ADDENDUM 1

Client: Indiana University
Project: NW 827 Anderson Library Conference Center Transformer Replacement
Client Project No.: 20222216
Applied Project No.: 23-111
Addendum No.: 1
Date: 3/24/2025

NW 827 Anderson Library Conference Center Transformer Replacement
Pre-bid Meeting Minutes

SHEET NUMBER
E301

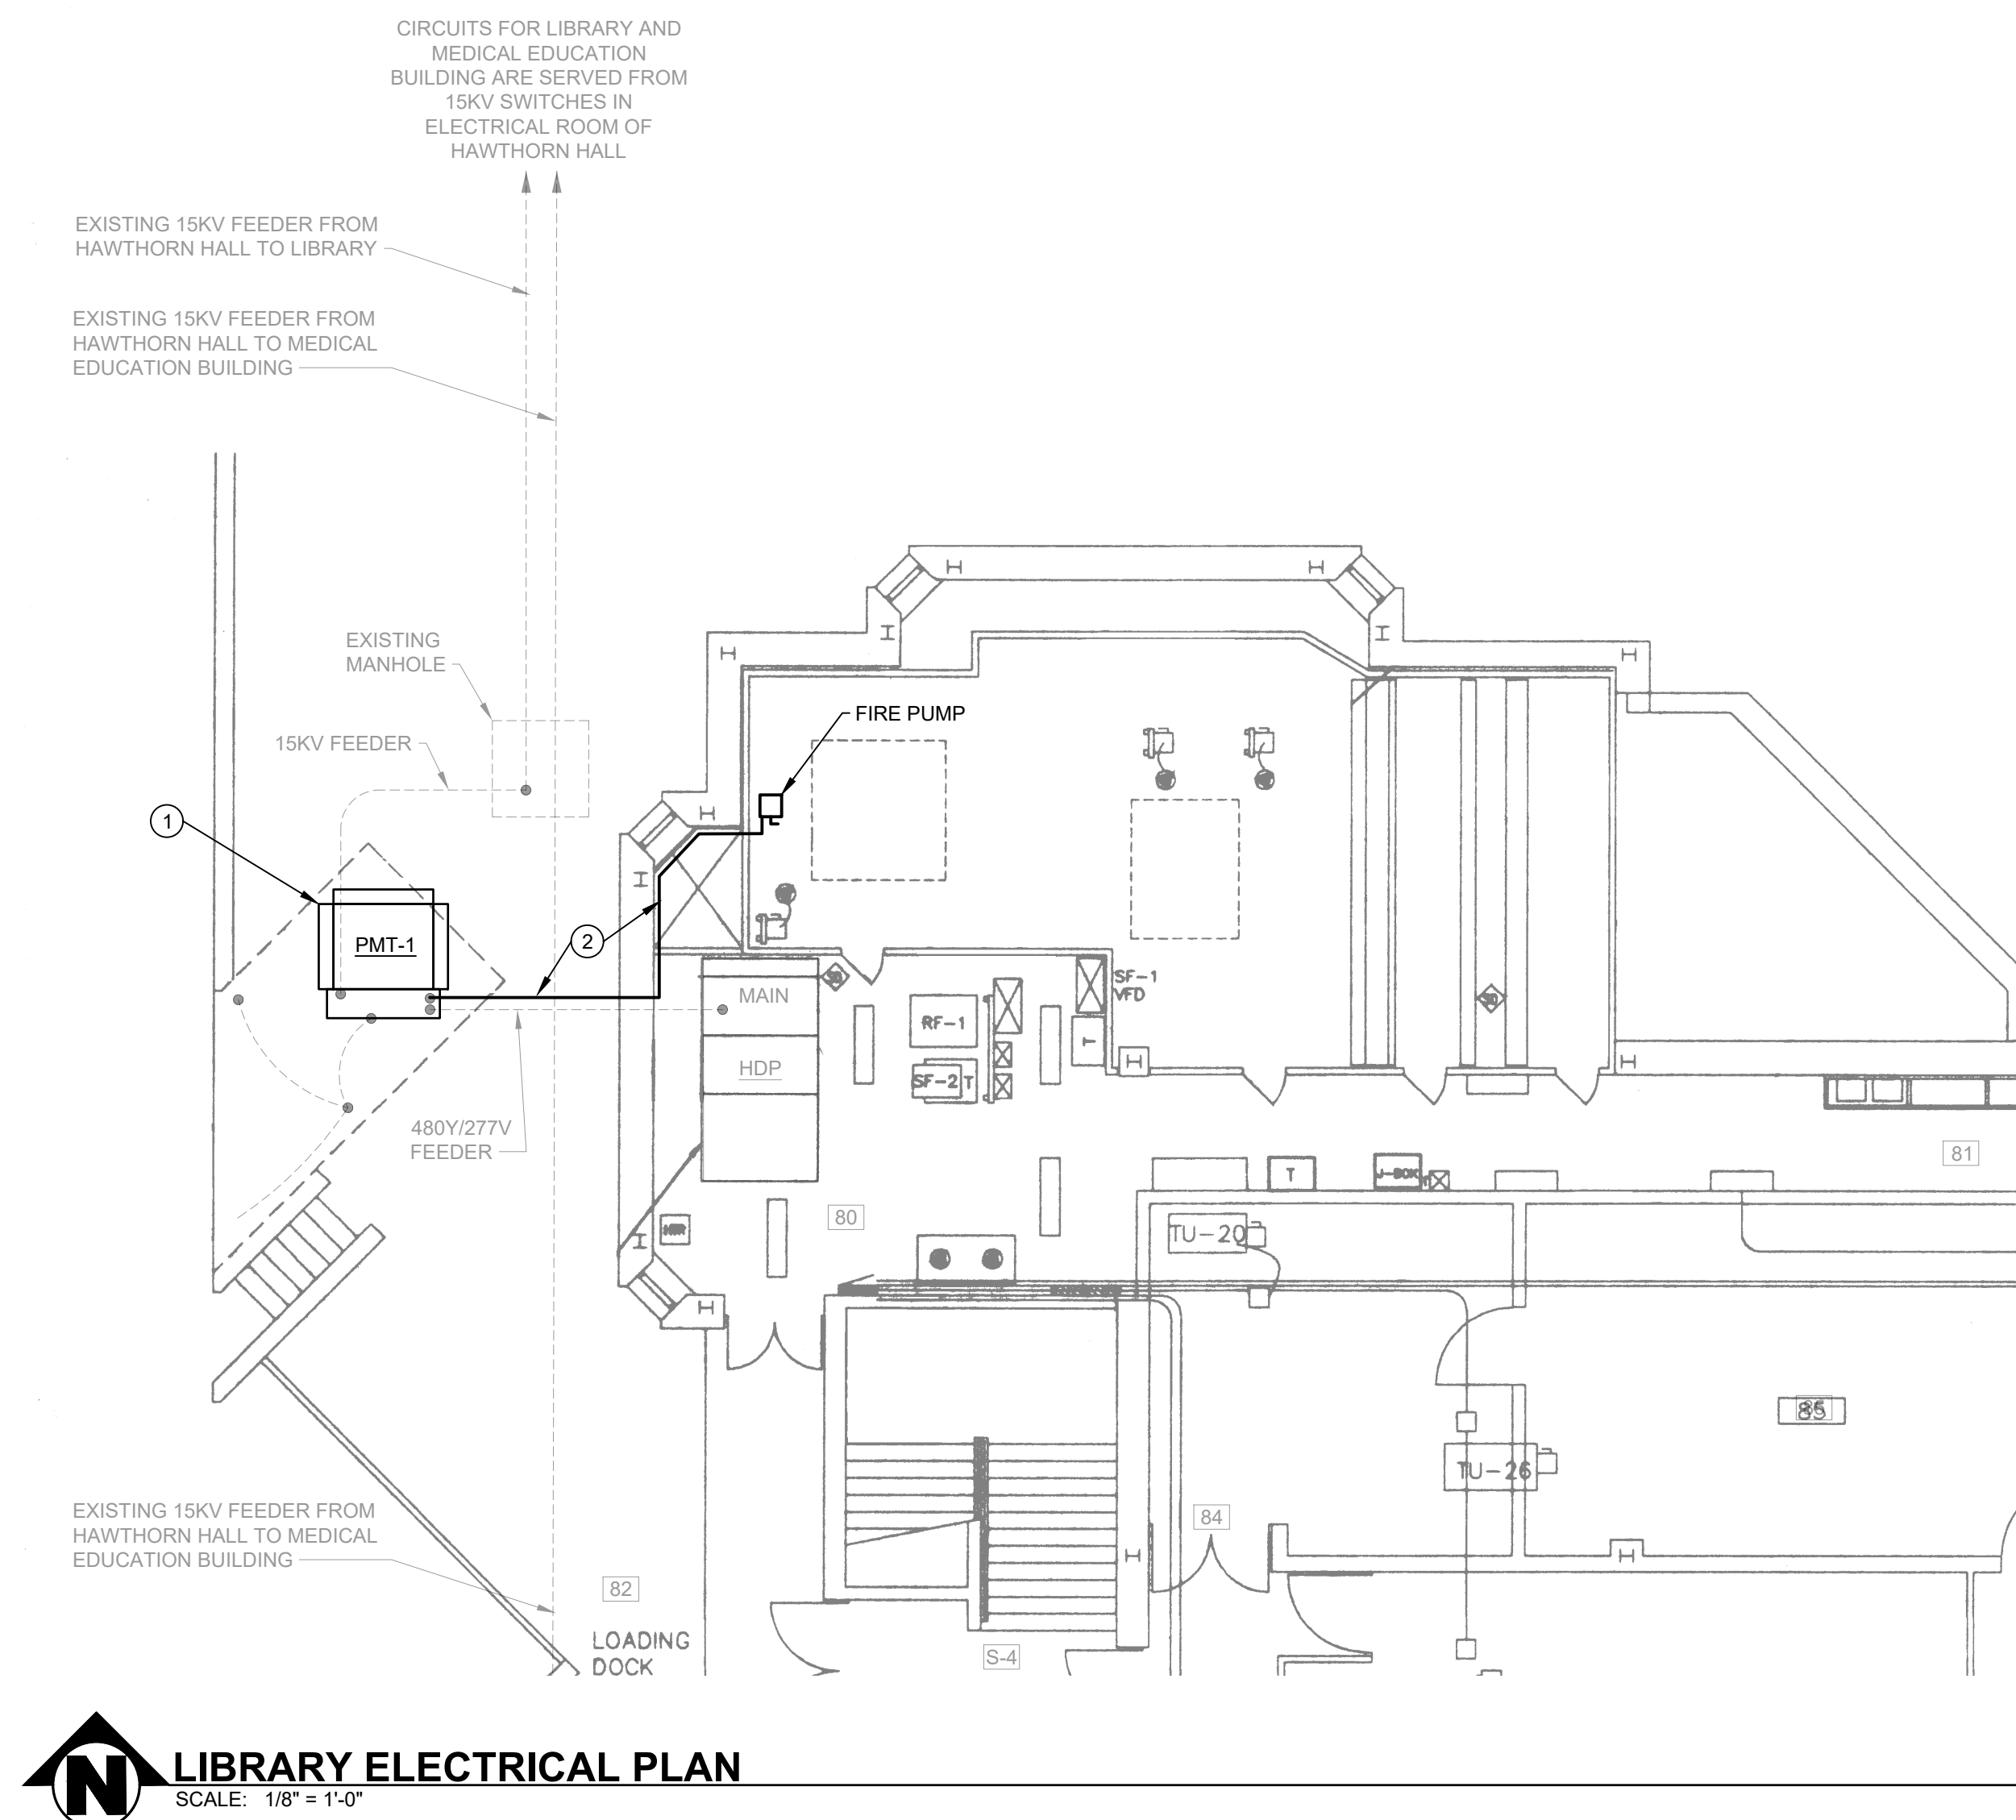
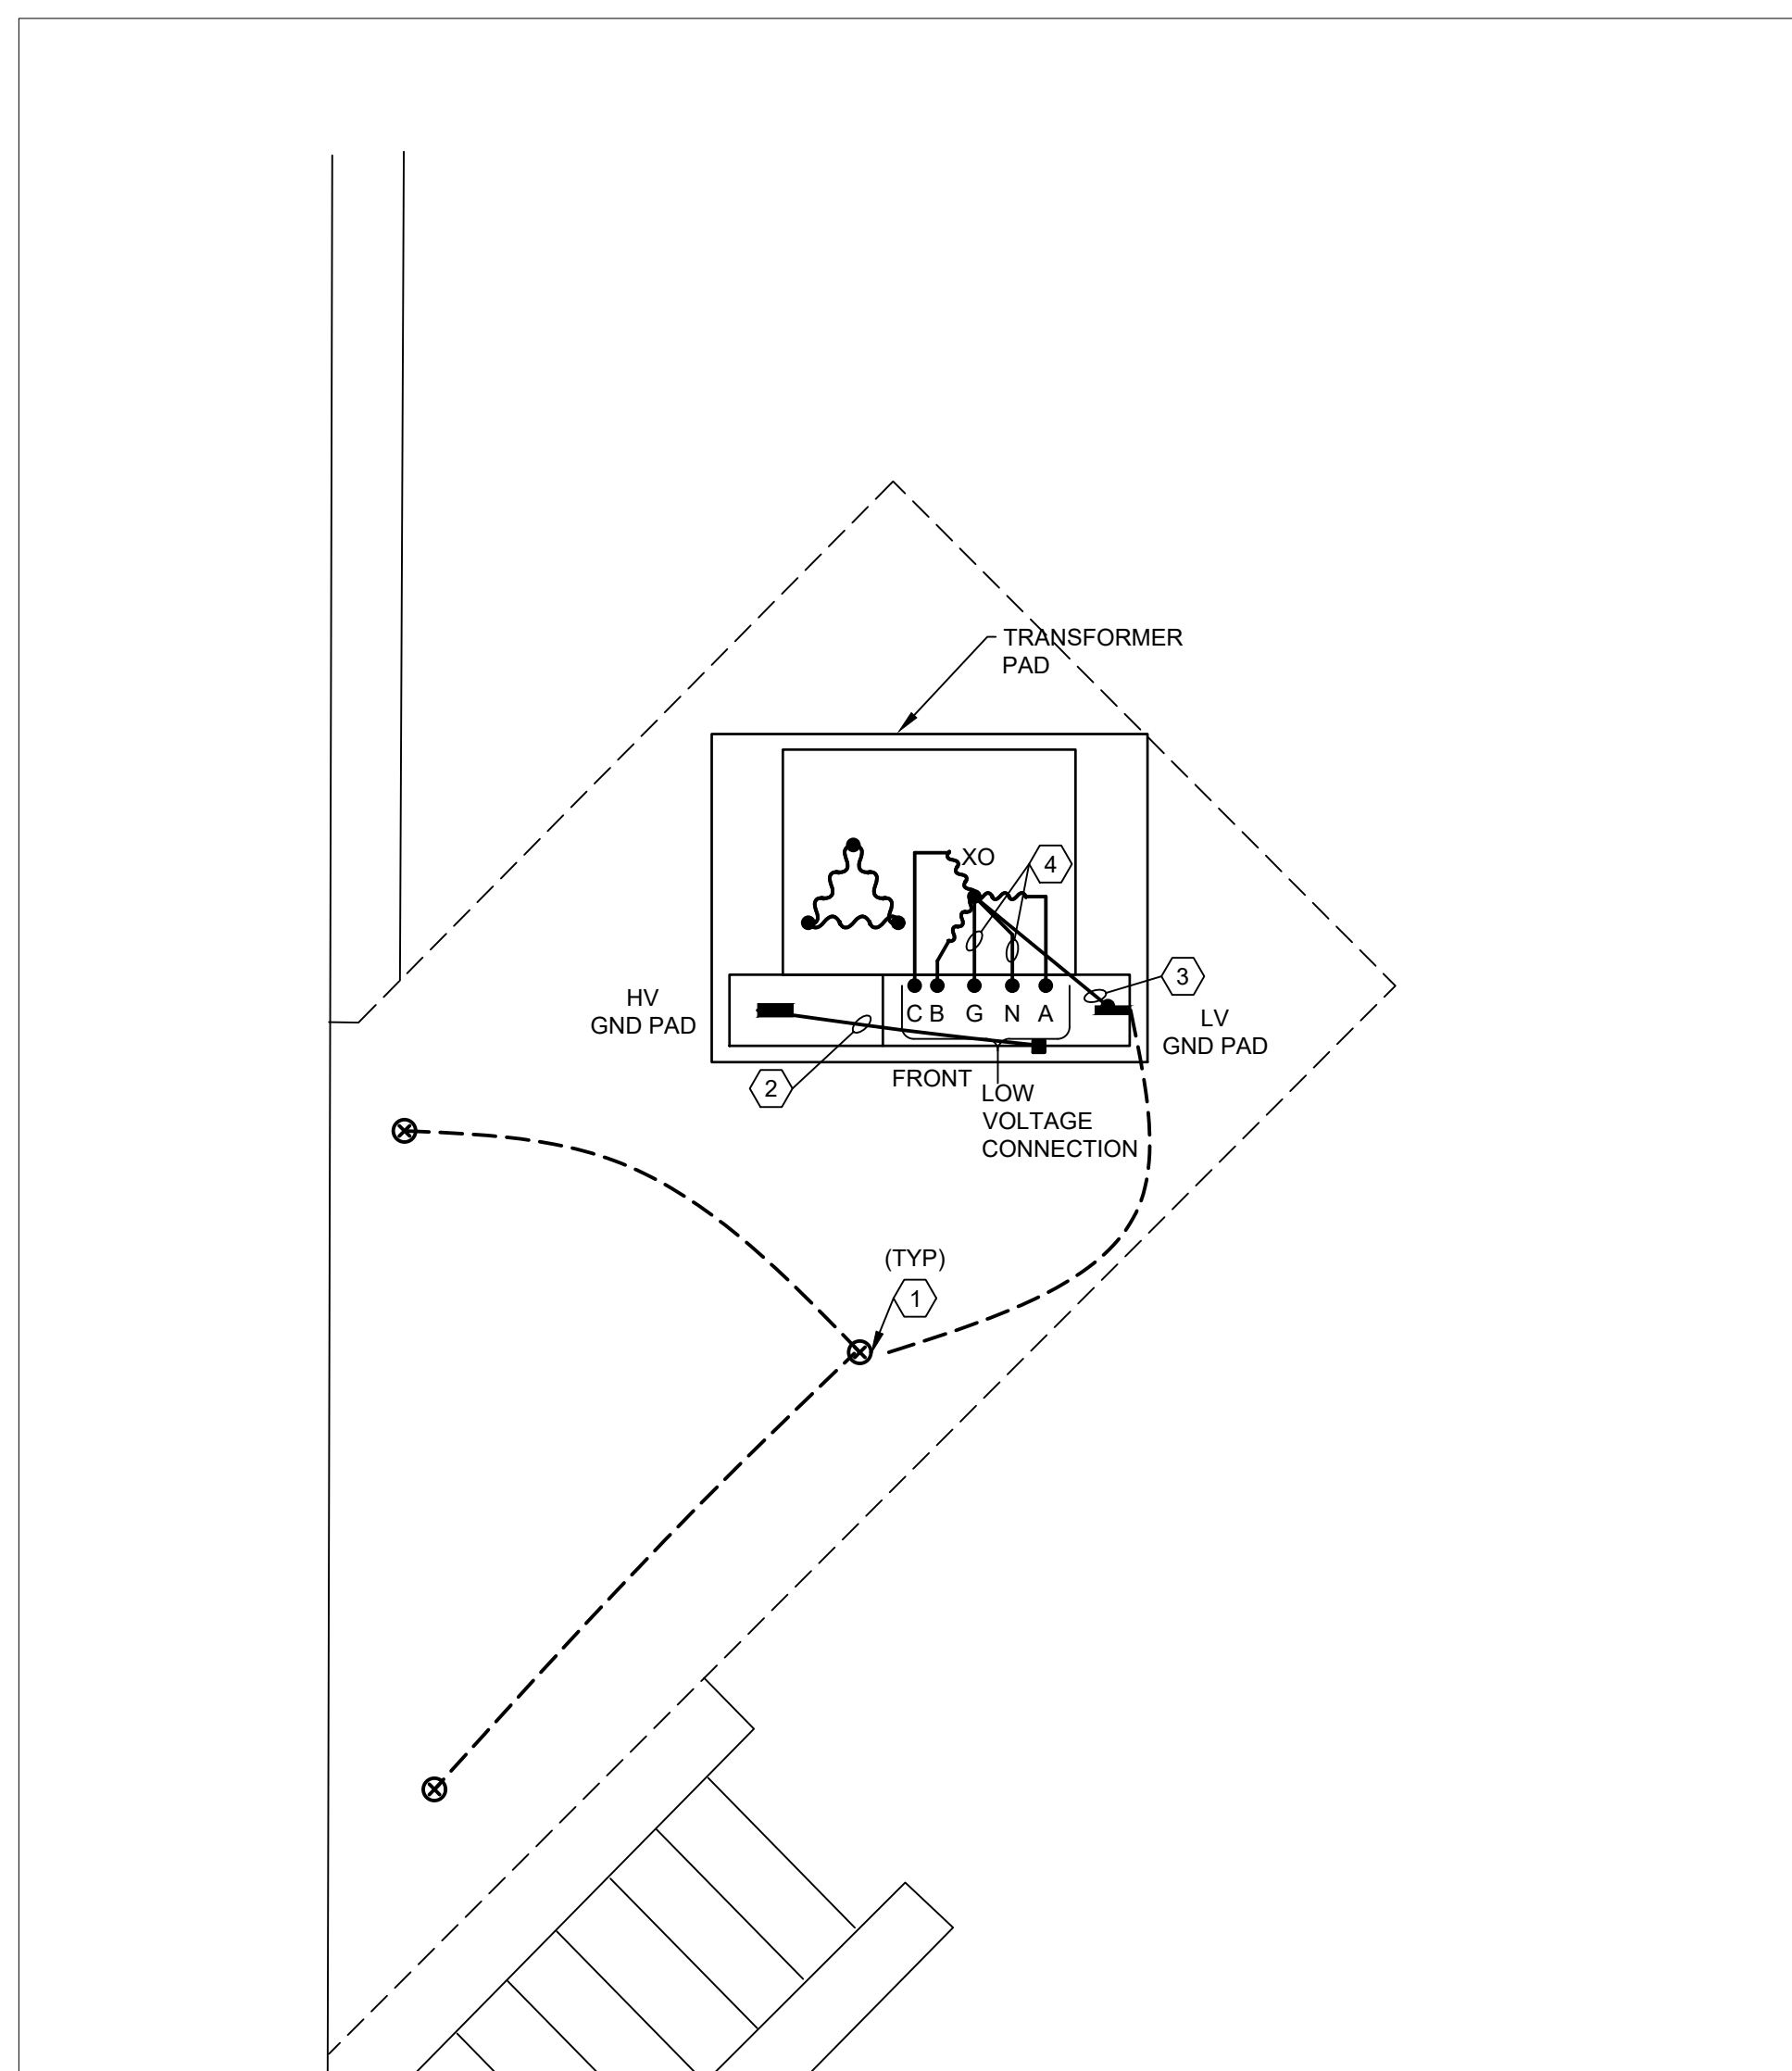
Drawing E301

1. Contractor to provide transformer.
2. Added Alternate # 1 – Provide refurbished transformer meeting current specifications.
3. Alternate # 2 – *Fire Pump Feeders: Contractor shall disconnect existing conductors and re-connect to newly installed transformer.*
4. Alternate # 3 – Contractor to drain existing transformer and make ready for storage. Contractor shall protect and store transformer for 6 months. Include all rigging and transportation from the project site and back to the project site. Contractor shall properly dispose of old oil and provide owner receipt of disposal.

7. An addendum to the construction documents is forthcoming. Items to include clarification of Plan Note 1 on sheet E301 to indicate the transformer is to be provided in its entirety by the contractor, not the owner. The addendum will also address the possible deletion of the fire pump feeder replacement pending engineering review.

- 1. PROVIDE PMT-1, PAD MOUNT TRANSFORMER, 2000KVA, 12.470V/480-277V, PADMOUNT, 5.75%Z. CONNECT TO EXISTING PRIMARY AND SECONDARY CABLING. PROVIDE GROUNDING PER DETAIL A ON THIS SHEET.
ALTERNATE #1 - PROVIDE REFURBISHED PAD-MOUNT TRANSFORMER CONFORMING TO ALL OTHER SPECIFICATIONS.

- 2. PROVIDE FEED FOR FIRE PUMP. 3" FIBERGLASS CONDUIT, (3) #20 & (1) #6GND POWER AND GROUND CABLING SHALL BE RADIX DURALIFE RHH/R90 TWO-HOUR FIRE-RATED CABLE. SEE CUT SHEET ON THIS PAGE. CONDUIT SHALL MEET CABLE REQUIREMENTS FOR 2 HOUR FIRE RATING. UTILIZE EXISTING OPENING IN BUILDING AND RUN CONDUIT ALONG EXISTING EXTERIOR WALL. SEAL OPENING IN BUILDING ENVELOPE TO BE WATER-TIGHT. CONDUIT ROUTES THROUGH EXISTING EXTERIOR WALL. PATCH AND PAINT WALL, AS REQUIRED. ROUTE CONDUIT ALONG WALL TO EXISTING FIRE PUMP PULL BOX LOCATED BELOW FIRE PUMP CONTROLLER.
ALTERNATE #2 - REUSE EXISTING FIRE PUMP CABLING. TERMINATE ON NEW TRANSFORMER.

- 1. REMOVE EXISTING PAD MOUNT TRANSFORMER. RETAIN SECONDARY AND PRIMARY CABLING AND TERMINATIONS.
- 2. REMOVE FEED FOR FIRE PUMP. REMOVE CONDUIT AND CABLE COMPLETELY. EXISTING FIRE PUMP CONTROLLER SHALL REMAIN AND BE PROTECTED. COORDINATE WORK WITH OWNER TO ENSURE BUILDING IS NOT OCCUPIED WITH DURING OPERATION OF FIRE PUMP.
ALTERNATE #2 - RETAIN EXISTING FIRE PUMP CABLING.
